Access Compliance Report

Public Rights-of-Way

Intersection ID: 16313	Main Street: BILLINGSLEY_RD	Cross Street: JONQUIL_ST	Location: NE
ADA ID: D60D55D7A49F	Ramp Type: PerpDiag	Initial Pass/Fail: Fail	Overall Compliance: No
Codes/Mitigation Info/Possible Solution		Field Measurements/Component Compliance	
Severity Score: 33.75

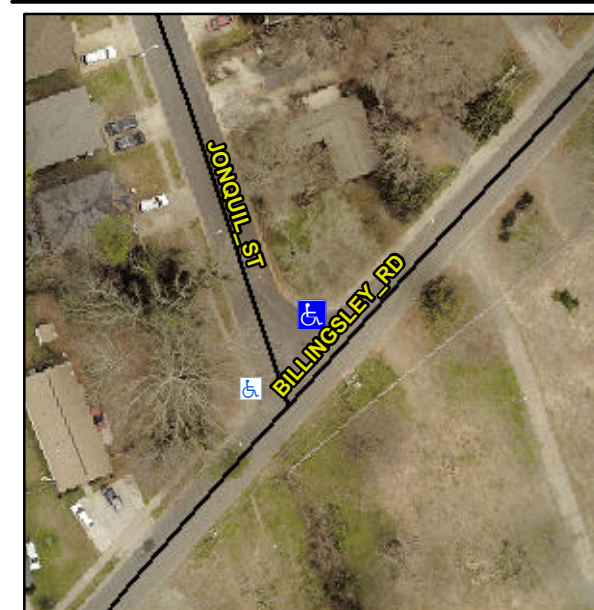
Not Found, R304.5.1, R304.2.2, R304.5.3

Compliance	Description	Data	Compliance	Description	Data
N/A	Ramp Length (in)	55.0	No	Ramp Slope (%)	8.9
No	Ramp Width (in)	42.0	No	Ramp XSlope (%)	6.0
N/A	Flare Type LT	N/A	N/A	Flare Type RT	N/A
N/A	Flare Slope LT (%)	N/A	N/A	Flare Slope RT (%)	N/A
N/A	Flare Traversable LT?	N/A	N/A	Flare Traversable RT?	N/A
N/A	Landing Length (in)	N/A	N/A	DWS Provided?	N/A
N/A	Landing Width (in)	N/A	N/A	DWS Contrast?	N/A
N/A	Landing Slope (%)	N/A	N/A	DWS Length (in)	N/A
N/A	Landing X Slope (%)	N/A	N/A	DWS Full Width?	N/A
N/A	Landing Curb? (Y/N)	N/A	N/A	DWS Offset (in)	N/A
N/A	Shared Landing?	N/A			
N/A	Gutter Ponding?	N/A	N/A	Gutter Slope (%)	N/A
N/A	Gutter Lip Ht (in)	N/A	N/A	Gutter X Slope (%)	N/A
N/A	Painted X Walk1?	No	N/A	Painted X Walk2?	No
	X Walk 1 Direction	To SW		X Walk 2 Direction	To SE
N/A	X Walk 1 Width (in)	N/A	N/A	X Walk 2 Width (in)	N/A
	X Walk 1 Slope (%)	0.2		X Walk 2 Slope (%)	7.6
	X Walk 1 X Slope (%)	5.3		X Walk 2 X Slope (%)	0.0

Remove & Replace Curb Ramp With Two New Directional Ramps or Equivalent.
